28 River Street – Zoning Amendment – Refusal Report

| Reference Number: | 16 268409 STE 28 OZ |

This report reviews and recommends refusal of the application to amend the Zoning By-law.

Attachment 2b: North Elevation

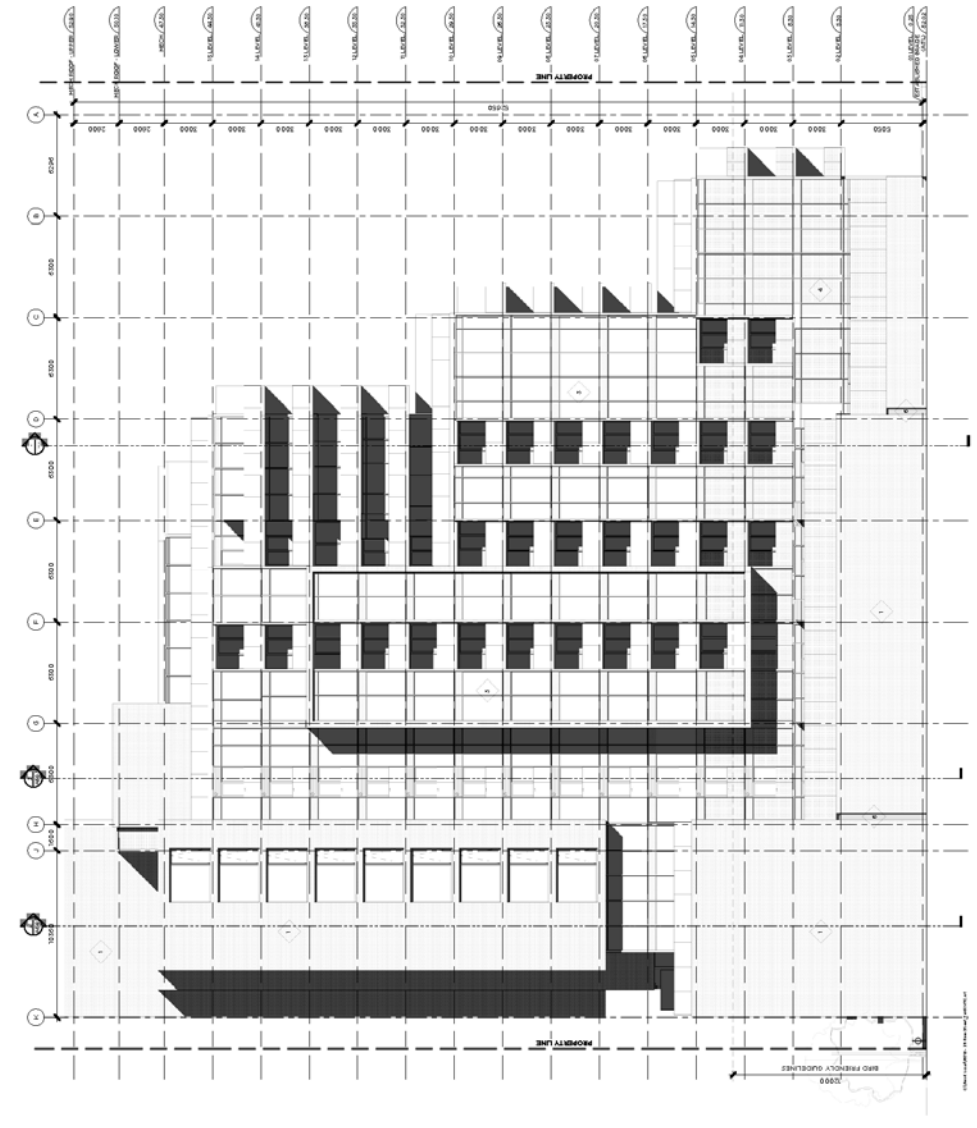
Under performance standard no. 5B, the required setback from a property in a *Neighbourhood* is 7.5 metres. The proposed building abuts the north side lot line with no setback on the ground floor. On floors 2 to 4 the front portion of the building with a depth of 12.2 metres also has no setback and the rear portion of the building has a setback in the range 3.9 to 5.5 metres. Floors 5 to 15 are set back from the north side lot line mostly in the range of 3.0 to 5.5 metres. Overall the proposed zero-metre setback does not provide sufficient transition to the adjacent *Neighbourhood*, especially with regard to the four-storey front portion of the proposed building that will abut the rear yard of the townhouse at 53 Wascana Avenue.

Performance standard no. 5B also specifies an angular plane applicable to the north side of the building that is measured from a height of 10.5 metres and set back 7.5 metres from the *Neighbourhood* property line. Less than half of the proposed building is within the north side angular plane. A substantial portion of floors 4 to 7 penetrate the angular plane, most of floors 7 to 10 penetrate the angular plane and floors 11 to 15 are entirely beyond the angular plane. Such a substantial encroachment into the angular plane demonstrates a lack of regard for providing a transition in scale to an adjacent *Neighbourhood* as required by Official Plan Policies 2.3.1(2)(b) and 4.5(2)(c).

A 45-degree angular plane measured from the north property line adjacent to the *Neighbourhood* is another method to provide suitable transition in scale, which is referenced in Section 1.3 of the Tall Building Design Guidelines. The angular plane serves to "limit shadow and overlook on neighbouring properties that are lower scale, and limiting shadow and loss of sky view on adjacent streets." The majority of the proposed building penetrates the angular plane.

Tower placement is further addressed in section 3.2.2 of the Tall Building Design Guidelines, which states that towers are to be placed "away from streets, parks, open space, and neighbouring properties to reduce visual and physical impacts of the tower and allow the base building to be the primary defining element for the site and adjacent public realm." Specifically, the tower should have a minimum 3-metre step-back from the base building facing the street. Facing River Street, the proposed tower has a step-back from the base building ranging from 1.8 to 4 metres on floors 5 and 6. From floors 7 to 15 the step-back is reduced to a range of 0 to 3 metres.
